ADDENDUM NO. 4

MENDENHALL 'A' ROOF REPAIRS

FOR: FLORIDA STATE UNIVERSITY

June 30, 2017

AD4

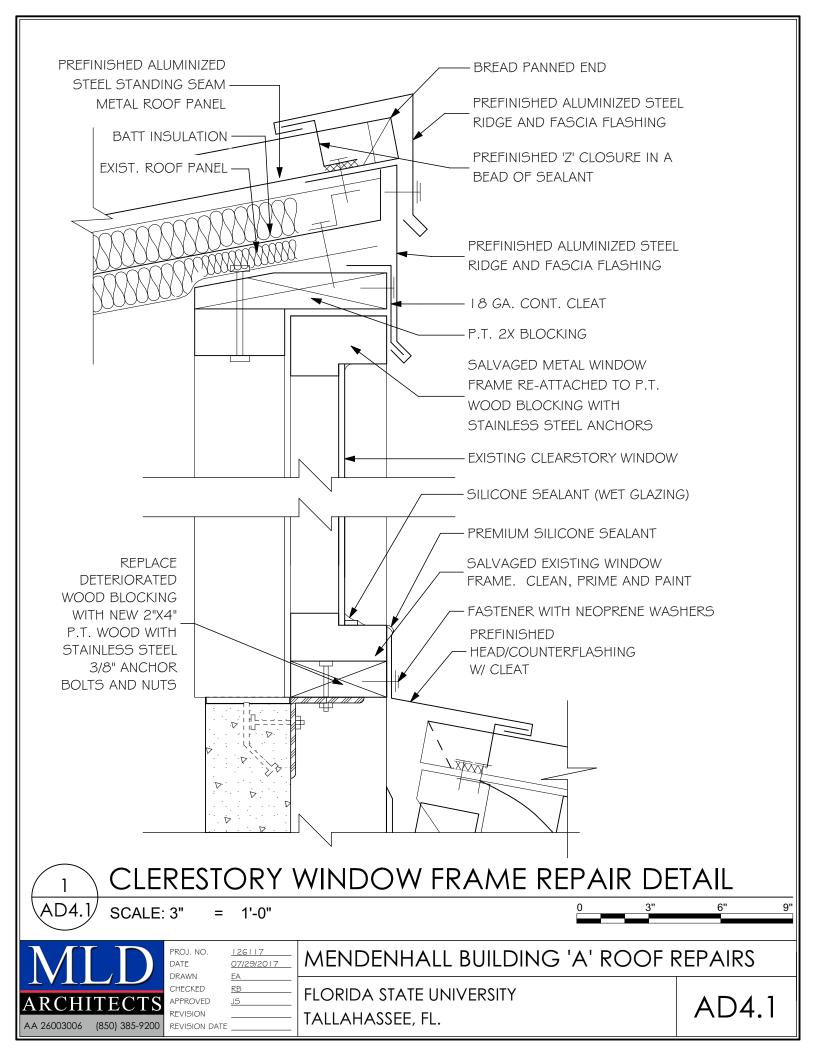
Add:

Contractor to carefully remove **two** section of clerestory window frames (4 panes in each section) above the northern end of Roof G. Remove the deteriorated wood blocking at the sill and replace with new pressure treated 2"x 4" blocking and new stainless steel 3/8" anchors bolts, counter sunk. Reinstall salvaged clerestory window frames into existing opening with new stainless steel anchors. Clean, prime and paint window frames and seal window frames and panes perimeter with premium silicone sealant, as detailed.

Addendum 4 – Photo #1

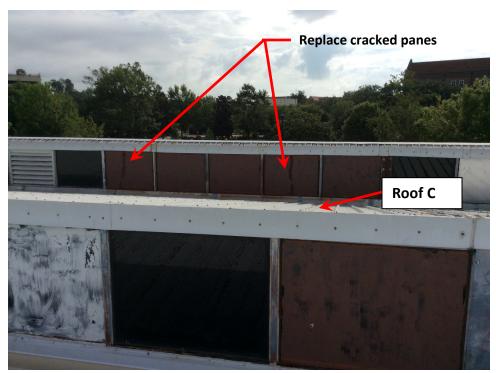
Contractor to replace broken/cracked clerestory window panes (2) above the narrow low slope roof of Roof C, that have been sealed with sealant and painted over (brown paint) with new panes, size and thickness to match existing. (See photo attached) Seal the perimeter with silicone glazing, as required.
